SUTTON CONSERVATION COMMISSION

MINUTES

Application Type: Notice of Intent
Project Location: 28 Horne Drive / Map 15, Parcel 45
Applicant: Andrew & Tara DeWolfe
Owner: Same
Representative: Hawk Consulting, Inc.
Inspection Date: 6/18/14
Memo Date: 6/20/14

**Subject: 39 West Millbury Road
Notice of Intent Plan Revisions**

Y - SECTION VIEW

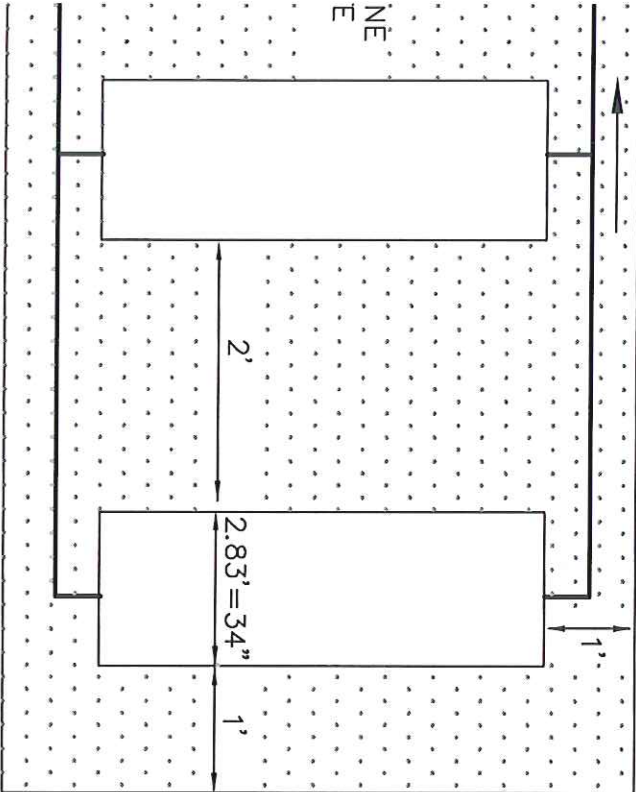
13) A 12" x 24' pipe has been depicted under the driveway at the prescribed location. My only comment is that I would like to see some stone at the outlet location to break up the concentrated flow through the pipe.

- Per the detail the road is 15 wide with shoulders? and 3 to 1 slopes. At the pipe crossing their is at least a 7 foot fill so the bottom of the embankment is 21 plus 15 plus 21 feet wide I do not know how you can only us a 24 foot pipe.
Again, the finished grading at the crossing was not depicted appropriately on the previous submittal due CAD layering and colors. The attached plans have been updated accordingly. With that said, the amount of fill from the bottom of the culverts to the proposed finished driveway grades is ± 3.2 feet and not the 7 feet suggested. However, we have revised the culvert lengths to 40-feet to accommodate the width of the fill embankment at the bottom of the slope.

Sheet 1 of 2 has been revised to depict a modified stone fill check dam around the downgradient side of this cross culvert outfall to break up the concentrated flow. I would also note that as required by the Gas Co., a swale detail has been added to Sheet 2 of 2 depicting the required turf reinforcement for the upgradient drainage swale.

REPLACEMENT TREES

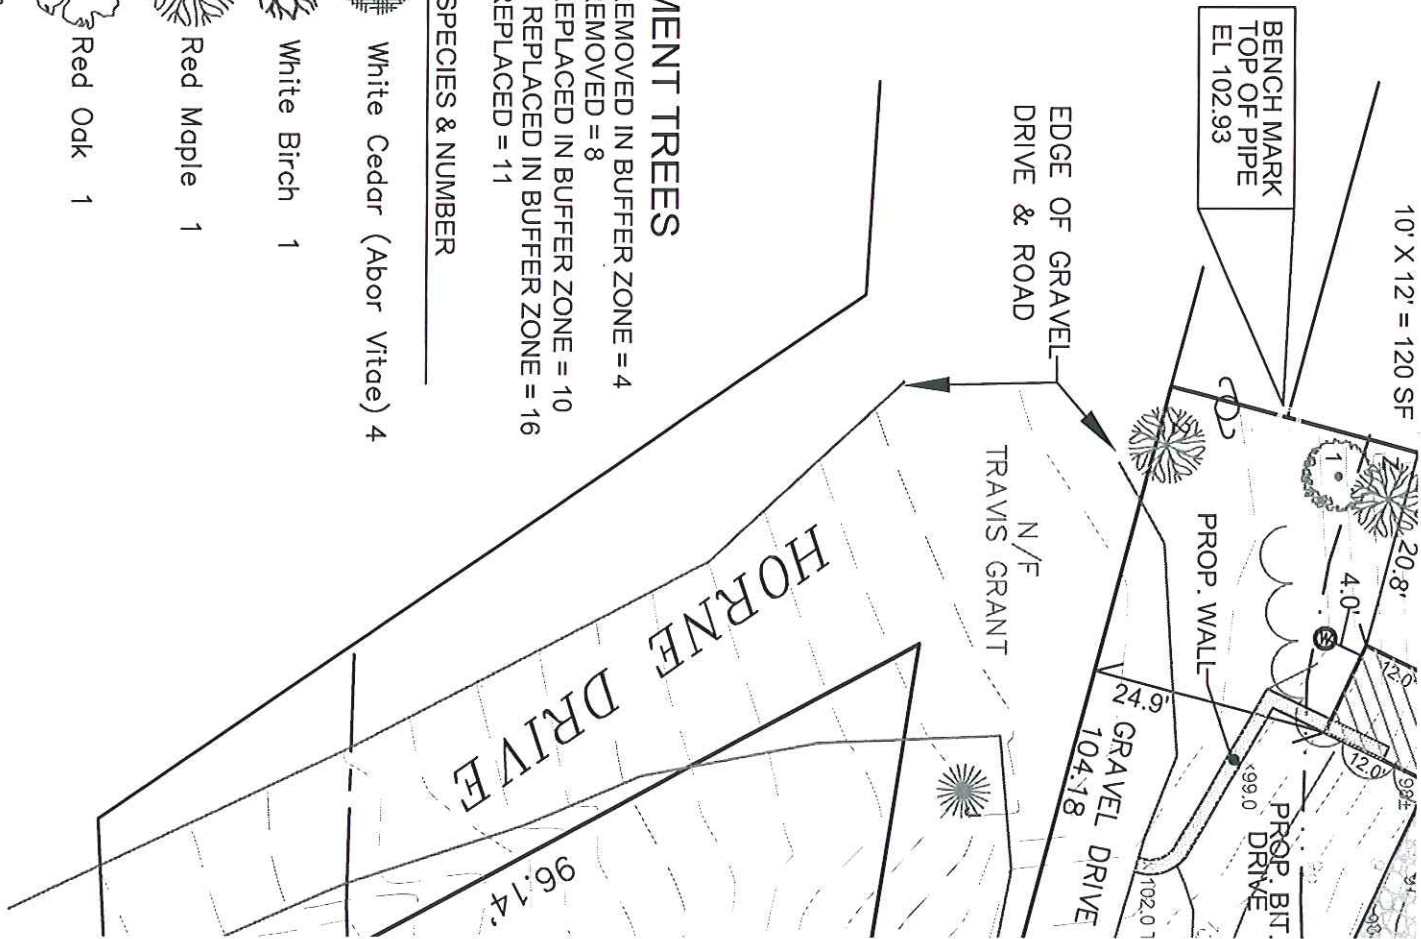
- Where are the trees being put?
The proposed trees were depicted on the plans submitted on 6/20/14 along the left (southerly) side of the Common Drive as you enter from West Millbury Road. These trees were required as part of the projects approval for a Common Drive as previously approved by the Planning Board.
